Technical Service Bulletin No. 21

Created by: Lab.gruppen AB Service Department

Reference no: C...X models

C20:8X, C10:8X, C10:4X & C5:4X

1. "New "components in Schematic.		
-----------------------------------	--	--

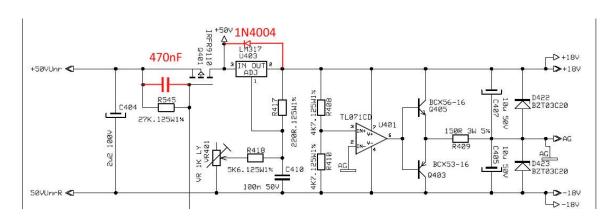
Part No.	Description	Amount	Info	Pos
1N4004	Diode Power 1n4004	1		See
				instruction
470n200VX7R	Capacitor Ceramic 470n 200V X7R 10%	1		See
10%5	5mm			instruction

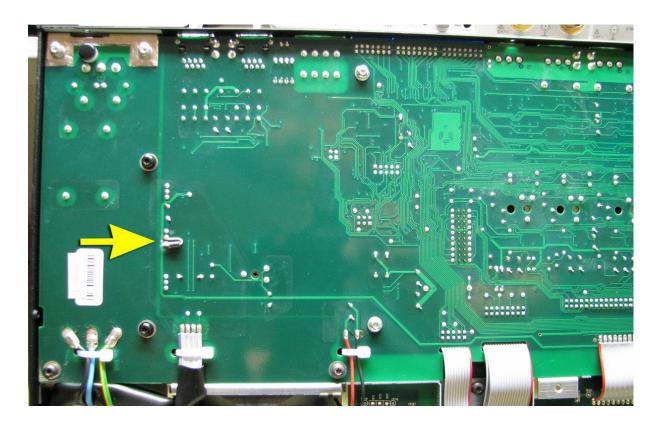
5. Form diode, cut legs and solder according to picture. Make sure that diode is close to pcb as possible.

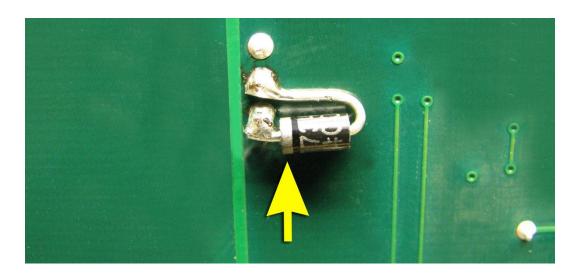
6. Note! Please note the direction of the diode. Incorrectly mounted major damage can occur.

7. Form capacitors legs according to picture.

8. Cut of legs according to picture.

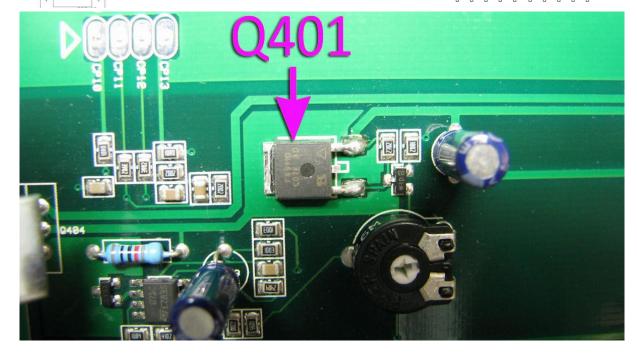
11. AICO4B overview. Capacitor should be placed on top of Q401.

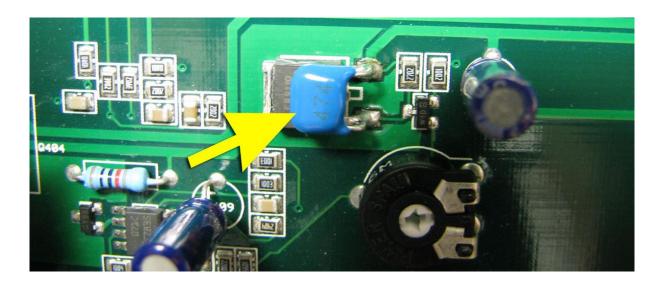
12. Solder capacitor according to picture.
